DATE: October 30, 2007
TO: Planning Department
FROM: *for* Larry D. Nelson, P.E., City Engineer
SUBJECT: Pumpkin Hollow Neighborhood Plan

The City Engineering Division has reviewed the subject neighborhood development plan and has the following comments:

Map 9: Transportation Plan - Pedestrian/Bicycle Facilities

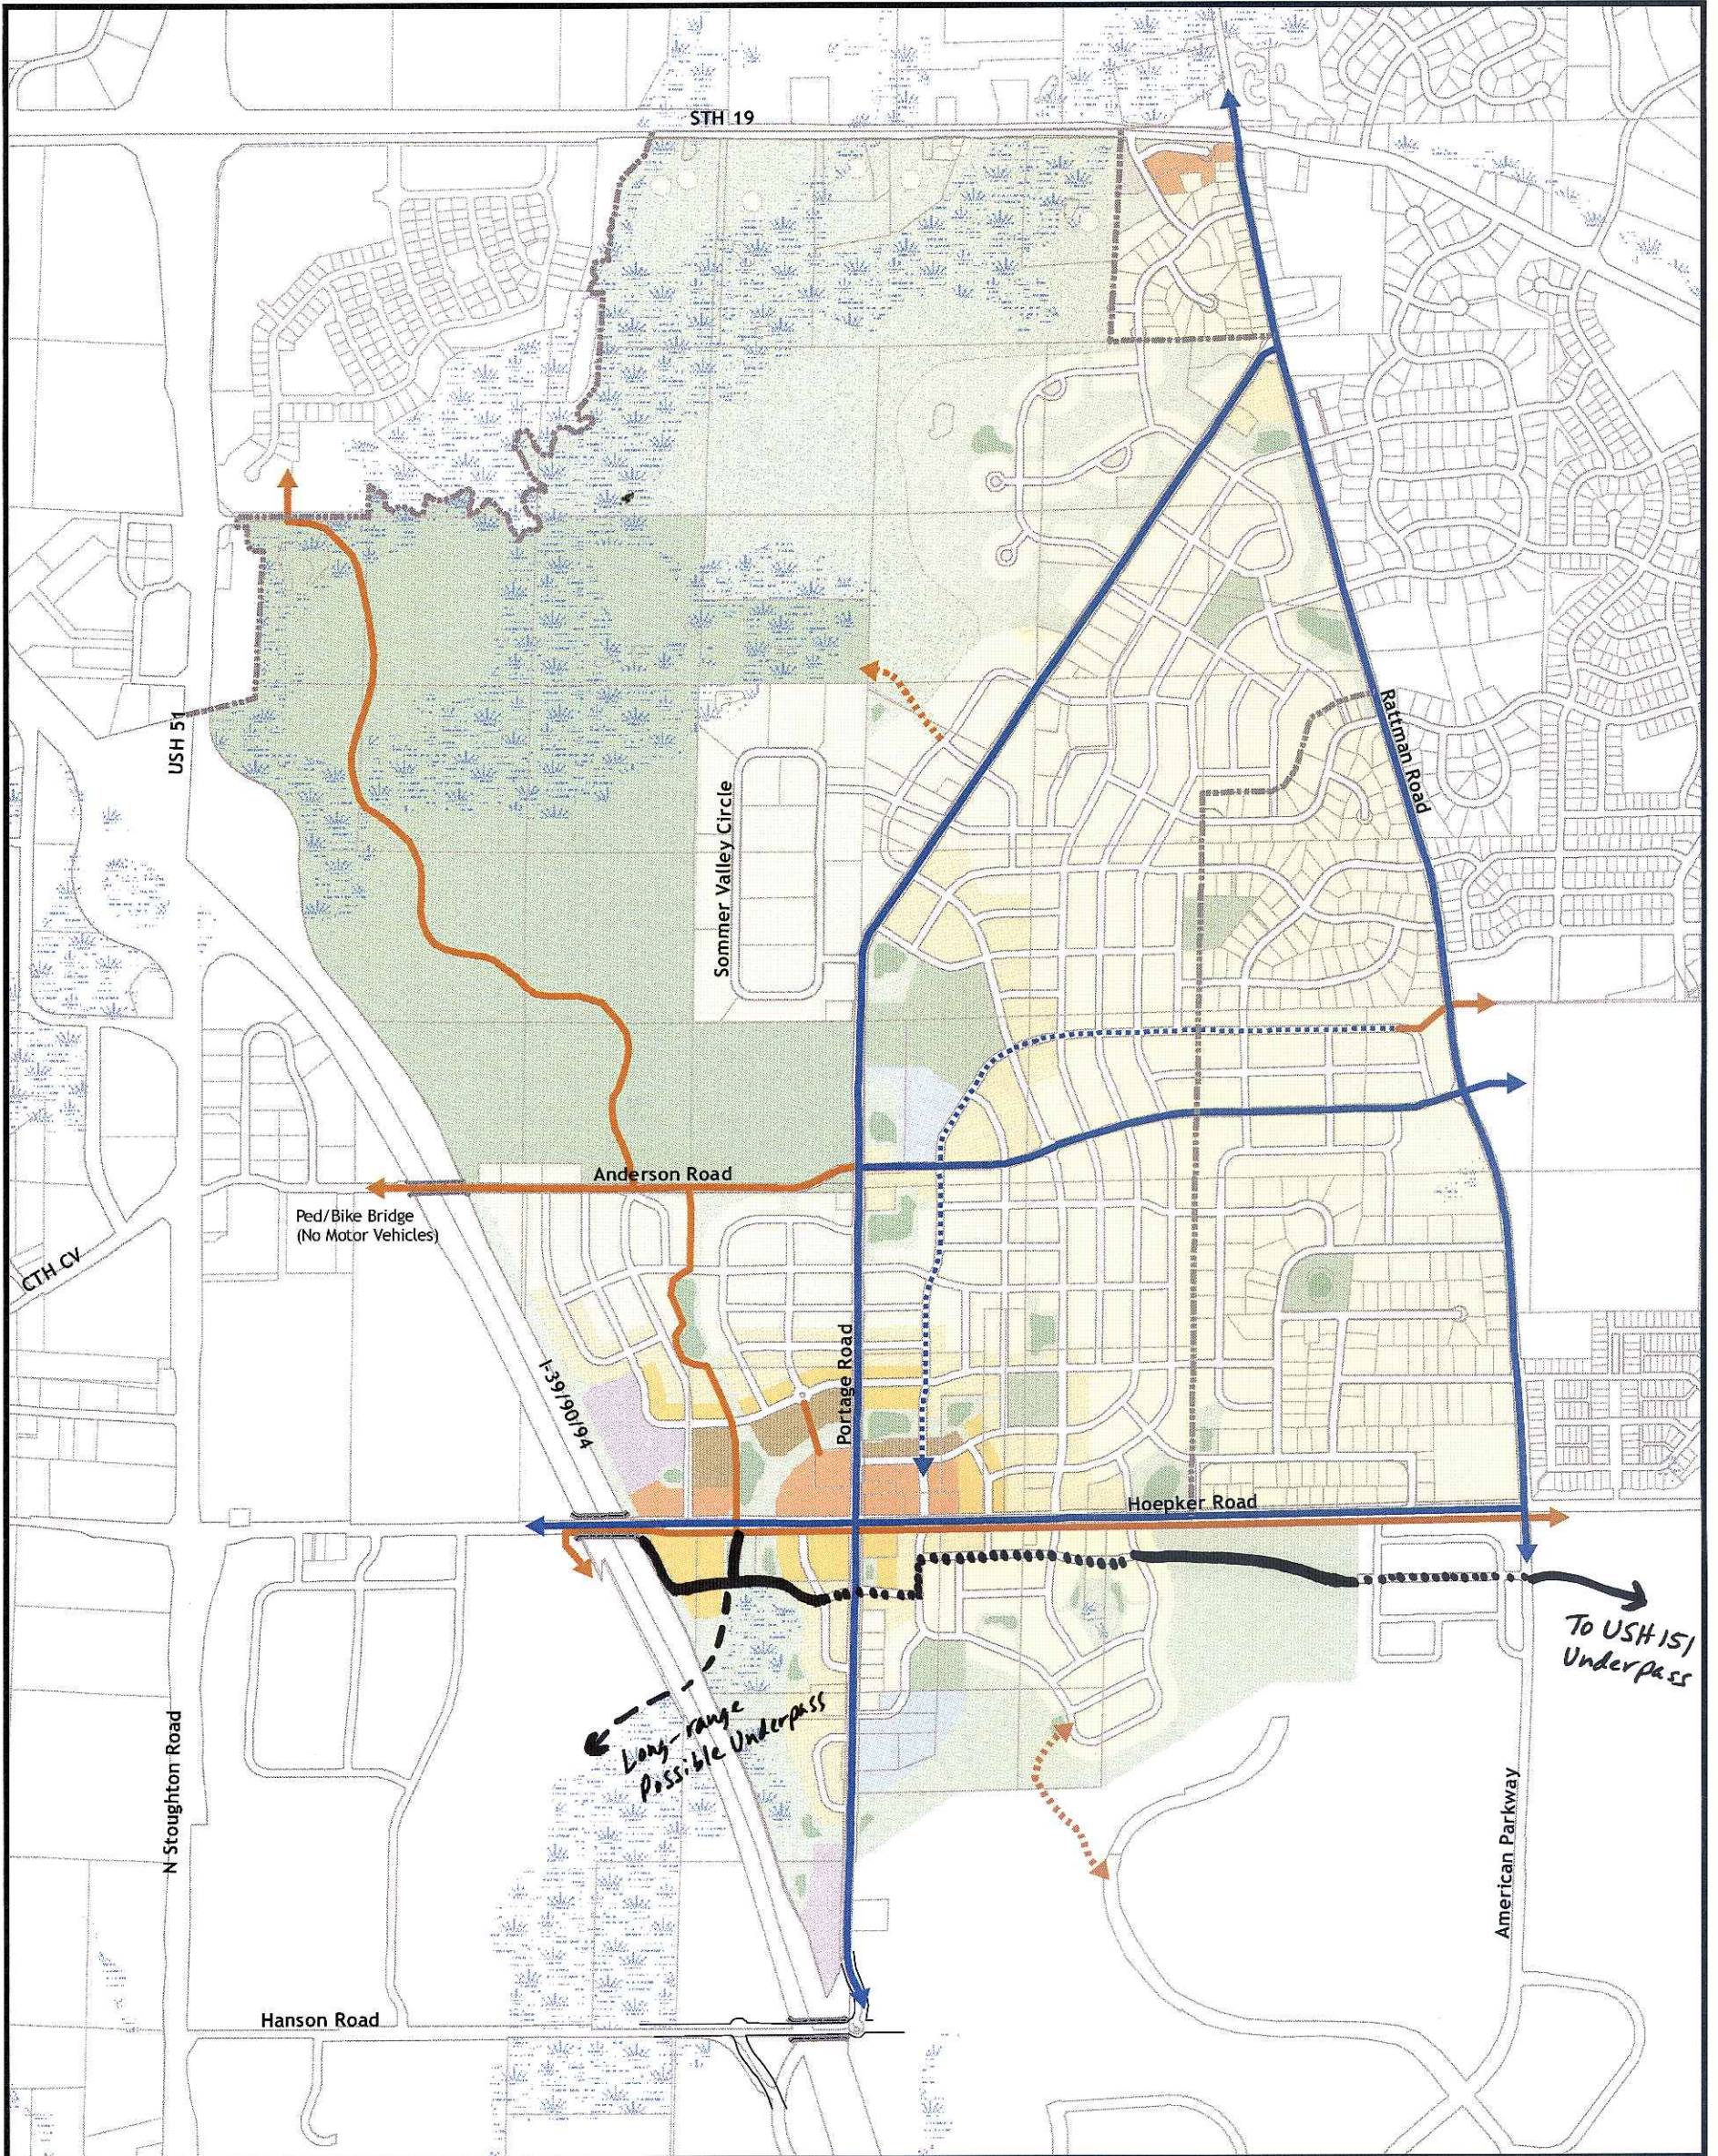
The East-West path located in the Hoepker Road Right of Way is not a desirable location. Path crossings in close proximity to intersections along busy streets are not desirable and in many respects equivalent to cycling on a sidewalk. Safety concerns are the result of the turning motorists who are not expecting a cyclist and in many cases not looking in the direction the cyclist is approaching as they are focusing on motor vehicle traffic at the intersection. The City Engineer recommends a path location about one block south where the path crossings can be made more safely. A possible alignment is attached.
